Fish Passage Plan (FPP) Change Request Form

Change Form # & Title: 16MCN001 – Added FOGs to Figure MCN-1
Date Submitted: December 17, 2015
Project: MCN
Requester Name, Agency: Lisa Wright, Corps RCC
Final Action: **APPROVED – December 17, 2015**

FPP Section: Figure MCN-1. McNary Lock & Dam General Site Plan.

Figure MCN-1. McNary Lock & Dam General Site Plan.

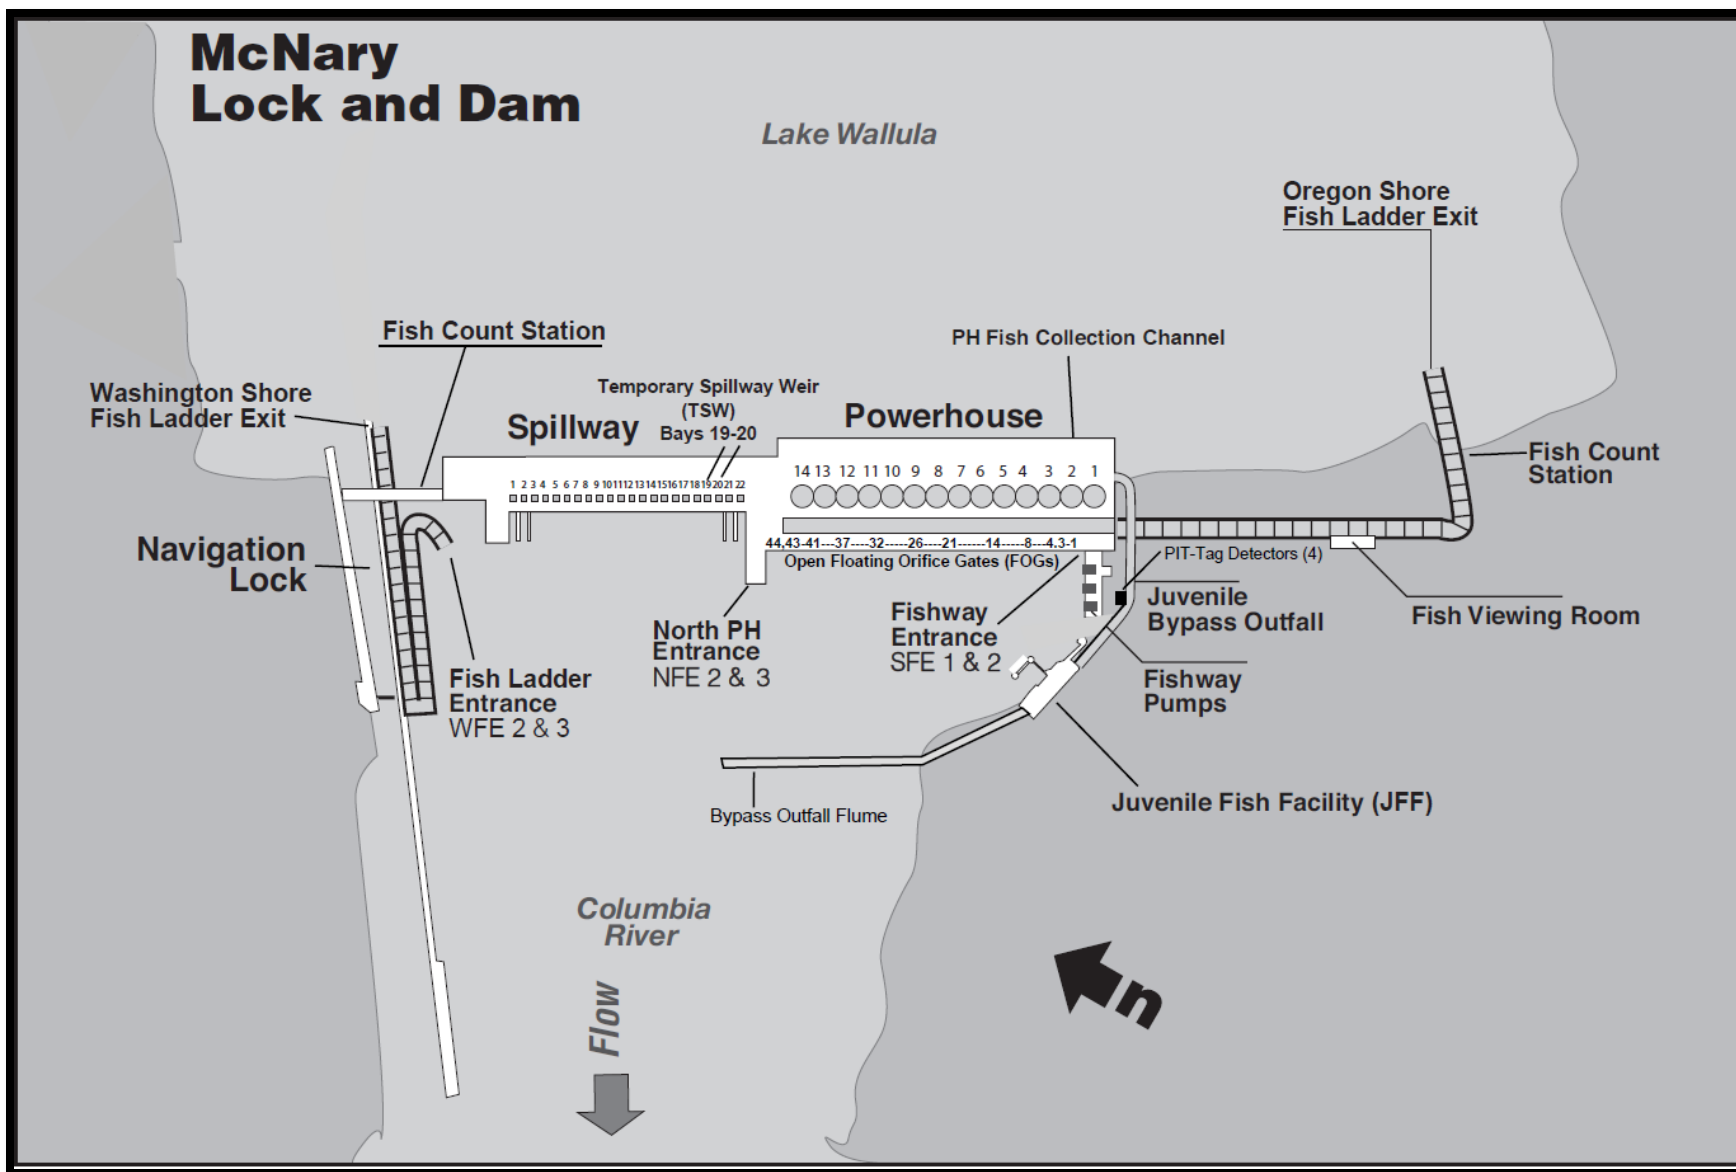
Justification for Change: FPOM was updated at the November 2015 meeting regarding ongoing maintenance of the McNary Dam floating orifice gates (FOGs). FPOM requested a schematic showing the locations of the open FOGs.

The FOGs start in the south corner of the powerhouse at number 1 and are evenly spaced to the north corner number 44. The twelve open FOGs numbered on the figure are: 1, 3, 4, 8, 14, 21, 26, 32, 37, 41, 43, 44.

See Figure MCN-1 on next page with open FOGs numbered along the powerhouse.
